TOWN OF CASTLE ROCK COLORADO

TECHNICAL MEMORANDUM

Title: Technical Criteria Variance Application

Name: Castle Rock Industrial Park – Untreated Runoff

SHEET D1.0

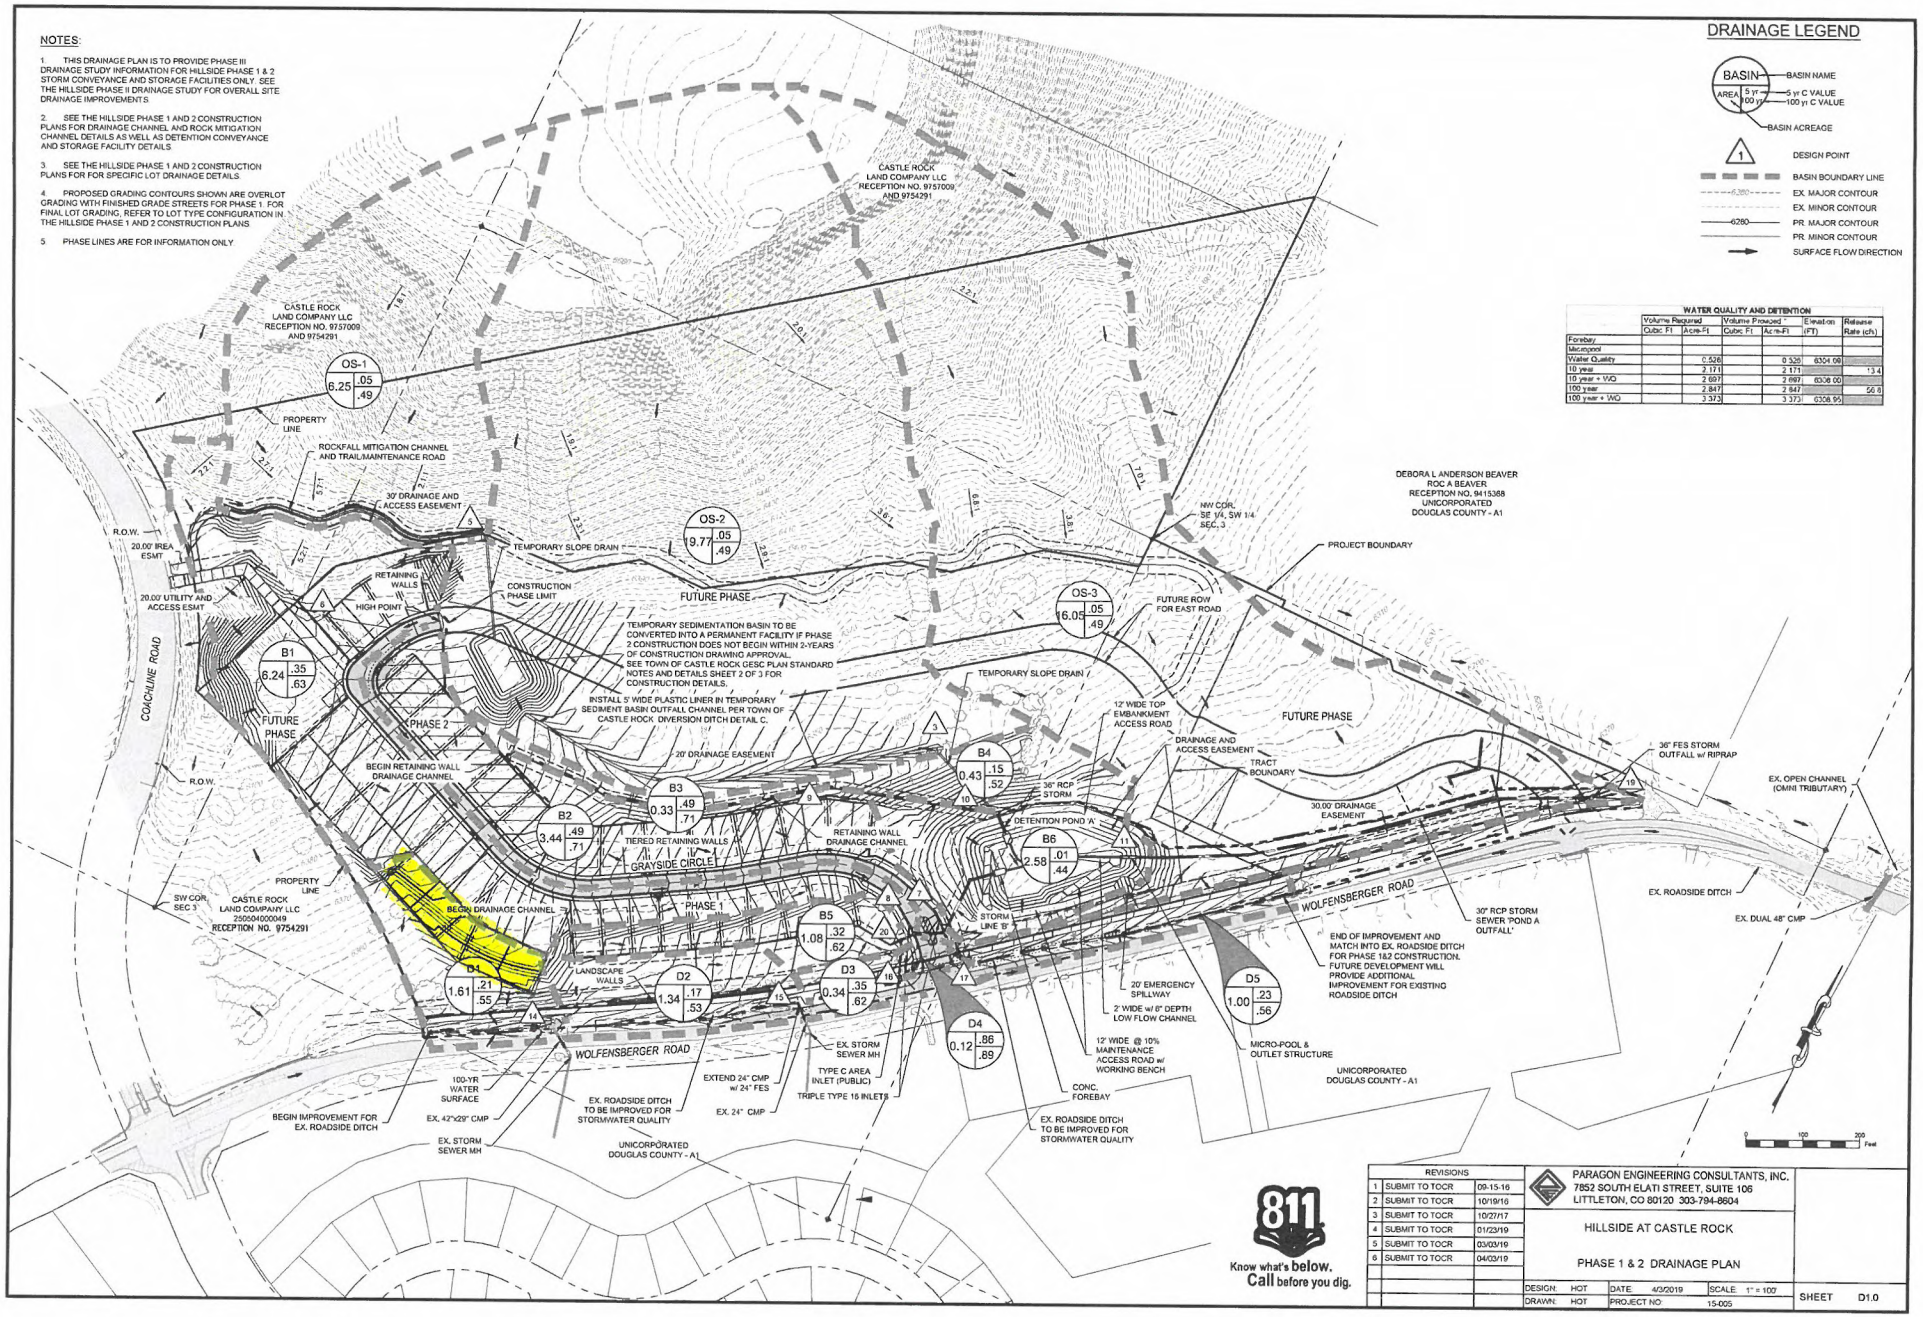
Summary: Due to the topography constraints of the site and surrounding areas, 6.1% of the site (3.07 acres) will not convey to the full-spectrum detention pond. Of this area, less than 1.0 acre will be developed as impervious area.

Discussion: Section 13.1.4 of the Storm Drainage Design and Technical Criteria Manual: *New Development projects shall require that full-spectrum detention be provided for the entire site.*

Staff has reviewed the attached variance request and finds that it meets the general intent of the MS4 permit section I, part E.4.c.iv.(A)1 which allows for up to 20% of the area of the site to discharge untreated subject to physical constraints, not to exceed 1.0 acre. The applicable untreated area of the development is 0.49 acres.

The entire development site is captured and treated through a WQCV facility with the exception of offsite pervious areas and 0.49 acres of developed impervious area.

Basins D1 and D2 are tributary to existing culverts in Wolfensberger Rd that convey runoff to the major drainage channel on the south side of Wolfensberger Road. Providing water quality and detention is not possible due to existing IREA lines and utility easement, which would obstruct pond and pipe installation. Basin D4 overlays the paved intersection of Grayside Circle and Wolfensberger Road. Stormwater improvements would be too low in elevation to convey runoff to the proposed Detention Pond A.

A. Basins D1 and D2 are not tributary to Detention Pond A.

B. Existing IREA utilities near the surface along the southern boundary of the site (north of the Wolfensberger right of way) control grade and prevent the installation of drainage channels or detention ponds and pipes in this area.

C. Basin D4 is too low in elevation to drain to Detention Pond A.

Sub-Basins D1, D2, and D3 are mainly open-space areas and represent a very small portion of developed area. Since most of the basins are landscaped area, runoff will be very similar to historic flow rates. The runoff will pass through native grasses and roadside ditches, which will provide some bioretention of pollutants.

Recommendation: ____X_____ **Approve** _____ **Deny**

For these reasons, I recommend approval of this variance.

Staff Recommendation: Approved ☑ Yes ☐ No
